FEI PATTULLO GAS LINE REPLACEMENT PROJECT
CPCN EXHIBIT A-7

Re: FortisBC Energy Inc. – Application for a Certificate of Public Convenience and Necessity for the Pattullo Gas Line Replacement Project – Project No. 1599129 – BCUC Information Request No. 2

INFORMATION REQUEST NO. 2 TO FORTISBC ENERGY INC.

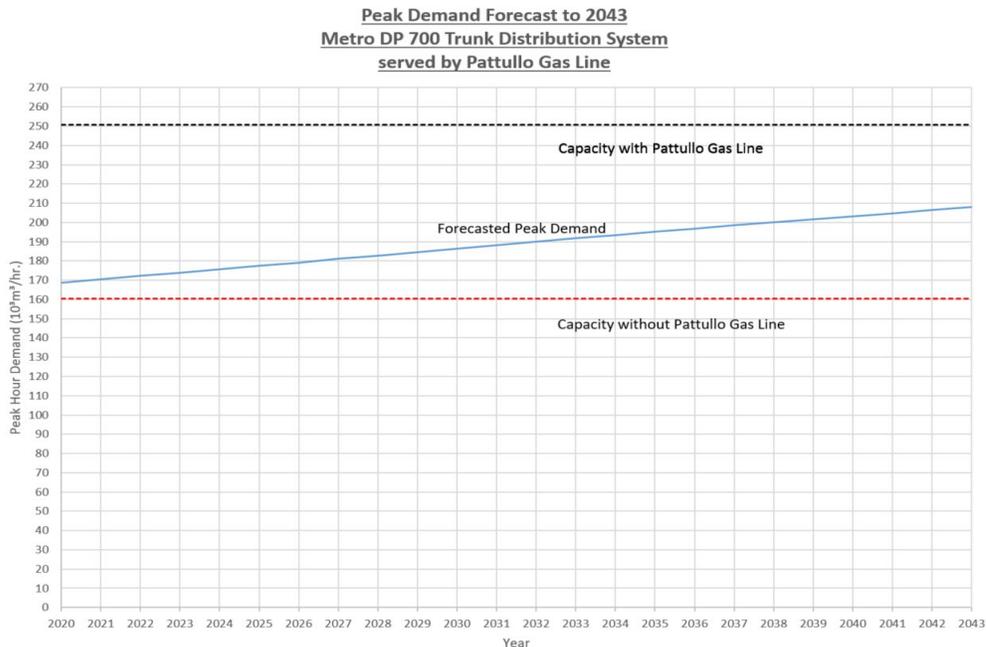
In response to CEC IR 5.5, FEI provided the following figure which shows peak demand and available system capacity, both with and without the Pattullo Gas Line.

- 31.1 Please provide a revised version of the above figure which illustrates system capacity with the PGR Project (i.e. system capacity with the proposed new gas line but without the PGL).
- 31.2 Please quantify any surplus system capacity with the PGR Project for each year from 2023 to 2043. (i.e. system capacity with PGR Project in excess of the forecasted peak demand).
- 31.3 Please discuss whether there is an opportunity for FEI to reduce the PGR Project costs by

minimizing any surplus system capacity with the PGR Project.

31.3.1 Please describe any assessments to determine the optimal pipe diameter of the proposed new gas line, including engineering and cost studies and provide the results of these assessments.
